Subject: SCC Public review comments

All comments refer to Rev 4 of SCSI-3 Controller Commands (SCC), X3T10 Project 1047D.

Cmt: 3. 5.2.1.4 Peripheral device address method, p 18,19

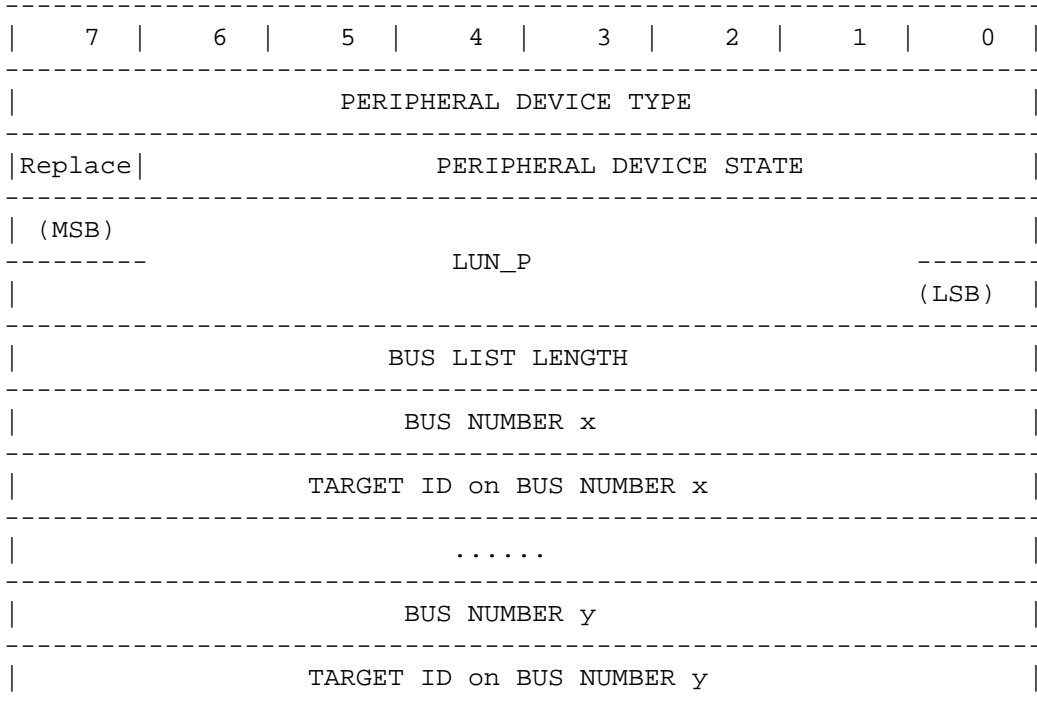
Table 6 describes the Peripheral device addressing and specifies BUS NUMBER and TARGET/LUN fields. In light of the dual port configurations of SSA and FC-AL devices along with the potential of dual ported SPI devices I believe BUS NUMBER as an integral part of the LUN_P is misplaced. I would propose that a LUN_P format use a 14 bit field similar to a LUN_V. The SACL would be responsible for tracking which bus a particular device was on. A variable number of BUS NUMBER/TARGET ID pairs could be reported as part of the REPORT PERIPHERAL DEVICE action. Specifically, I would change Table 25, Format of PERIPHERAL DEVICE DESCRIPTOR to the following:

Part of the rationale for this change is I believe BUS NUMBER and TARGET ID is important to the host for configuring purposes (to ensure maximum performance and redundancy by spreading a LUN_R across several buses). I want to avoid, however, the case where a SACL has been required to hide a path to a device (because of only one BUS NUMBER in the current LUN_P) but is actually routing all requests to the hidden bus and is implicitly lying to the host.
